**TOWER 2, LEVEL 23
DARLING PARK, 201 SUSSEX ST
SYDNEY NSW 2000**

ADDENDUM TO HERITAGE IMPACT STATEMENT: 85 HARRINGTON STREET, THE ROCKS, NOVEMBER 2018

This HIS is an addendum to assess proposed amendments under the modification.

Figure 8 – Rear courtyard elevation showing sculptural element.

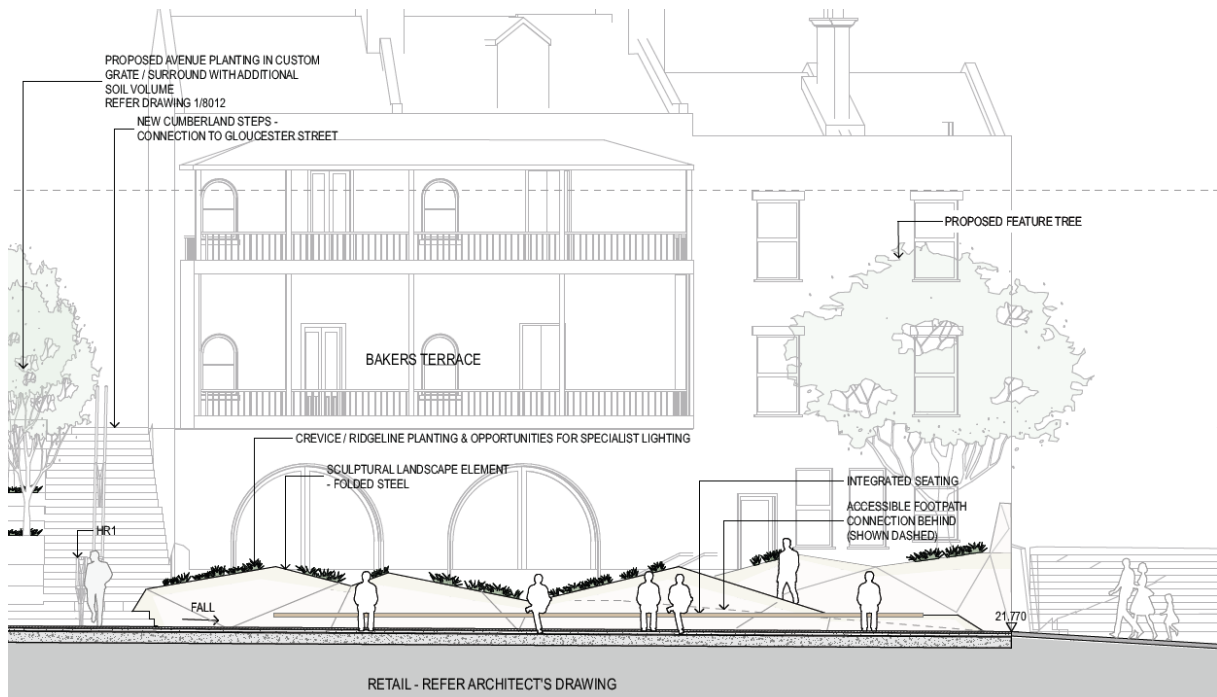
3.0 Landscape modifications

The landscape modification is a result of further design development and understanding of the complex level changes in this zone. The revised layout and levels is driven principally to provide a more integrated less intrusive equitable access to the basement and courtyard / laneway areas.

The major aesthetic change is the sculptural form that encases the access ramp and provides seating, planting and interpretation areas. This sculptural form has been designed in conjunction with artisans to provide a site-specific response to the courtyard that is contemporary. The design uses this regeneration opportunity to interpret the heritage context in a contemporary way in this highly public and unique space that is typical of The Rocks. The revised paving further defines the design to interpret the approximate location (exact locations to be confirmed) of the former Cumberland Place alignment.

Figure 12 – Bakers terrace previously approved and proposed ground floorplans

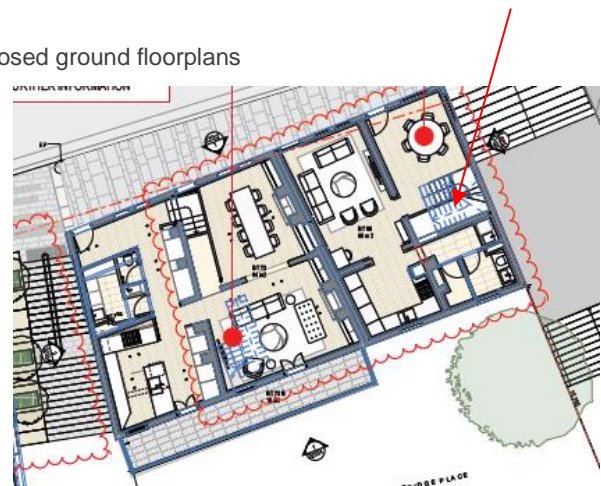
4.0 Internal stair to southern (right side) terraces relocated to front portion of the terrace.

The change of location of the stair presents no change or alteration to significant fabric and is proposed by the architects to achieve a more functional internal layout. This alteration has no effect on heritage significance and is therefore supported on heritage grounds.
(FJMT drawing note reference L2(i))

5.0 Relocation of dining room and bathrooms. Relocated to satisfy conditions of consent and the request from PMNSW, Strategic Planning and Heritage Division. This relocation is a positive heritage outcome as the new dining room more closely reflects the larger room layout to the front of the terrace. (FJMT drawing note reference L2(i))

Figure 14 – Bakers terrace previously approved and proposed first floor plans

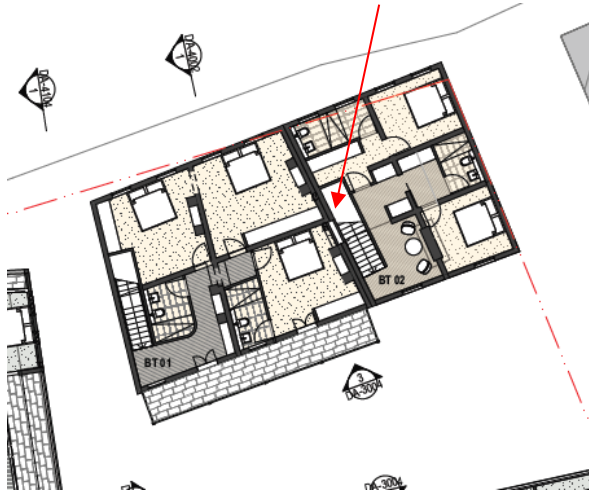
6.0 Relocation of the stair within the northern most terrace.

This is to retain the section of wall identified on the CMP as original / exceptional significance. This stair relocation also involves the relocation of bathrooms to accommodate its new position. This relocation has a positive heritage outcome as it is more appropriate to not have a bathroom on the front façade and retain this as a habitable room and locate the bathroom in the new central position.

7.0 Split Level bedroom to first floor of 68-70 Gloucester Street

Changes to the floor level to the norther pair of terraces (68) are proposed such that the FFL of level 1 is 29.650 to the two front bedrooms via a new floor frame on top of the existing structure. The front façade of the building is presented to the streetscape to match the windows aesthetically across the row of four. Due to this the site typography internal levels of the front bedrooms of the northern pair (to Gloucester St) have very high-level windows to bedrooms that are difficult to see out if and therefore provide reduced amenity to those rooms. This new level will involve the inclusion of two steps in the hallway to a new raised floor level to provide outlook from the bedroom windows. This new step and floor structure will sit on top of the existing as a new fame and will be completely reversible in the future if desired. Therefore, it is assessed that this element has no negative heritage impact from a heritage perspective. It enhances the amenity to make this a desirable space for residential occupation as per the original historic use.

Figure 16 - CMP significance map first floor

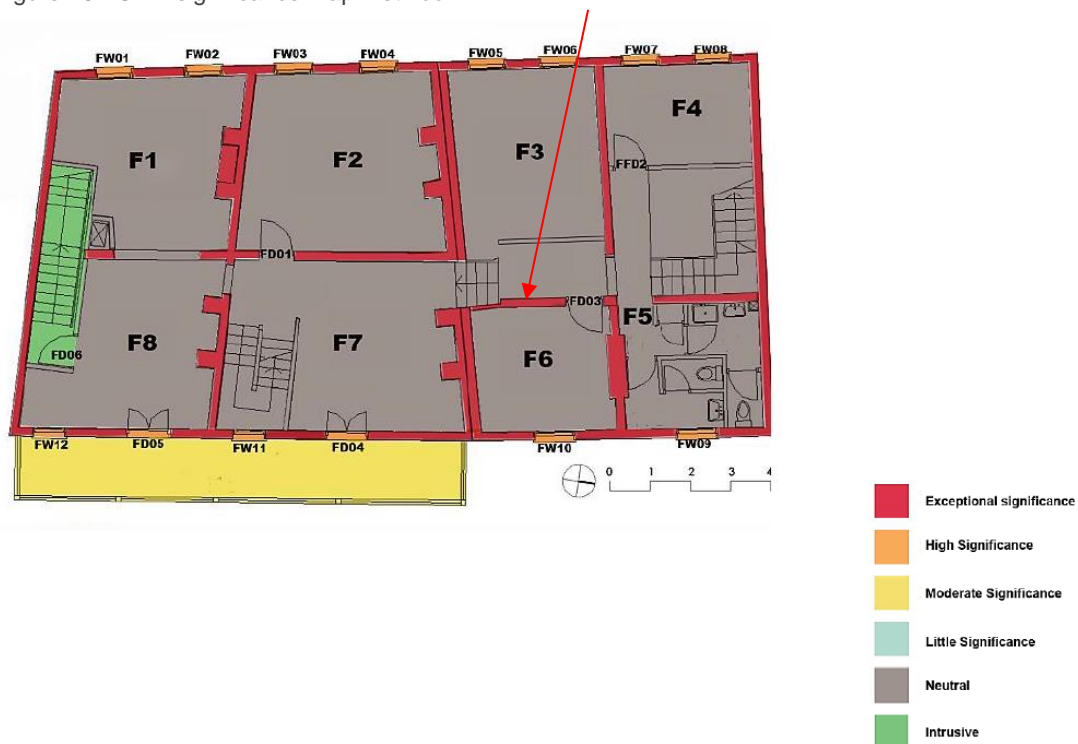
Relocation of stair and bathroom shown on prior plan to retain central wall shown here

Figure 17 – Proposed changes in plan to roof (area shown in red amendment bubble)

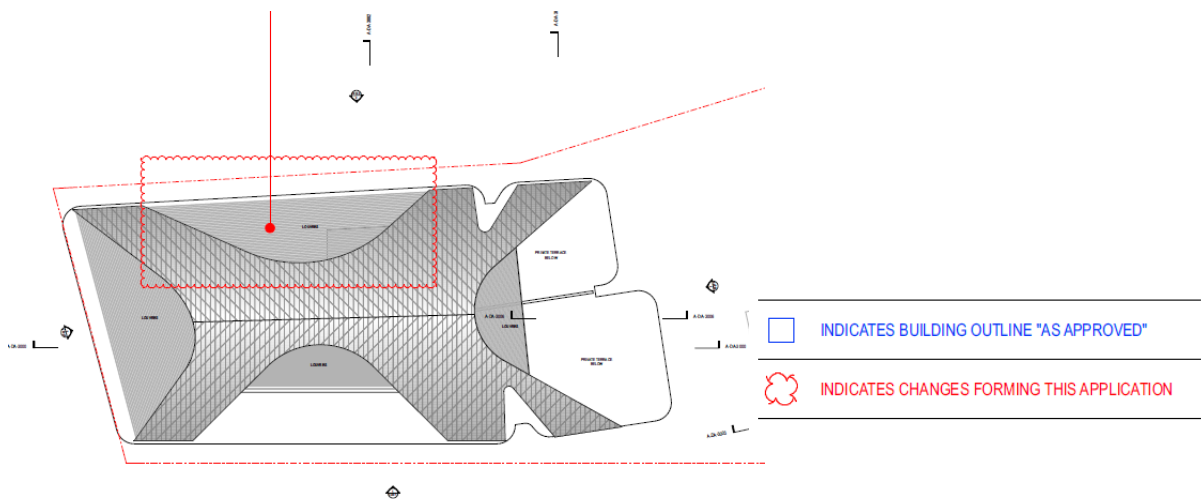
8.0 Additional louvred opening to roof on western side to provide ventilation for plant

The proposed changes to the roof do not alter the overall form, scale or presentation of a solid roof form and therefore have no change to the impact assessment on heritage grounds.

Figure 20 – Harrington Street facades.

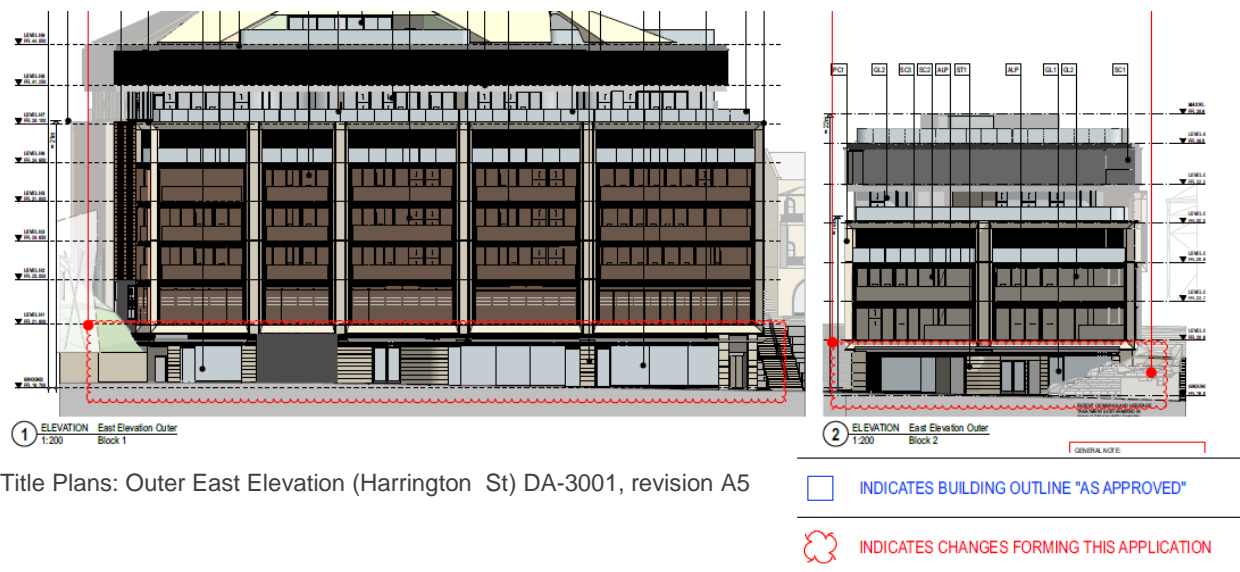
10.0 Minor alterations Harrington Street facades, and outer north

The changes are minor and related to internal planning and facade detail design layouts. They do not alter the design intent or architectural language response to the heritage context.

We also note the sandstone blockwork and bedrock to the northern corner at the stair junction is being retained in situ, the contemporary building wraps in behind.

In addition to the above, we also advise for reference that the current drawing set has been updated to correct a previous minor error in the original submission. The basement doors to Bakers Terraces that front Cumberland Place are to be retained as the existing opening. The previous drawing set showed this opening incorrectly. This detail is located on drawing DA-3004, detail 1 East Elevation Outer.
